NDS Document Transmittal #175756

Document Action Request

Document No.: CP 3804M Rev. No.: 1 Chg. No.: 1

Title: PASS Ventilation Samples

Attachment 10
3HVQ-RE49 Filter Housing Configuration
(Sheet 1 of 1)

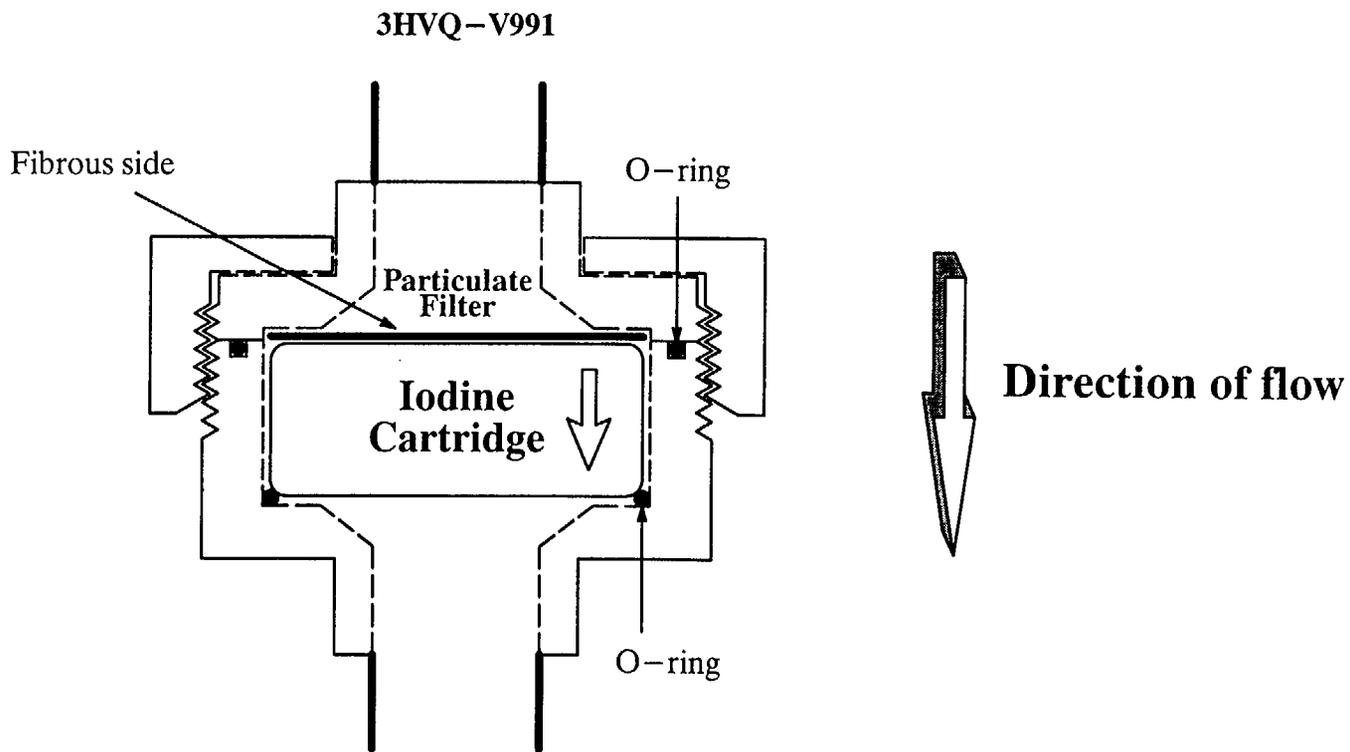
Modified procedure and added Attachment 10 to reflect new collector assembly installed under DCN DM3-00-0258-99

- Modified procedure and added Attachment 10 to reflect new collector assembly (iodine cartridge and particulate filter holder) installed under Reference 6.11.

4.7.8 Refer To Attachment 10 and PERFORM the following: ①

- a. INSPECT O-rings on HVQ 49 iodine-particulate sample holder.
- b. REPLACE O-rings as required.
- c. PLACE iodine cartridge and particulate filter into sample holder.
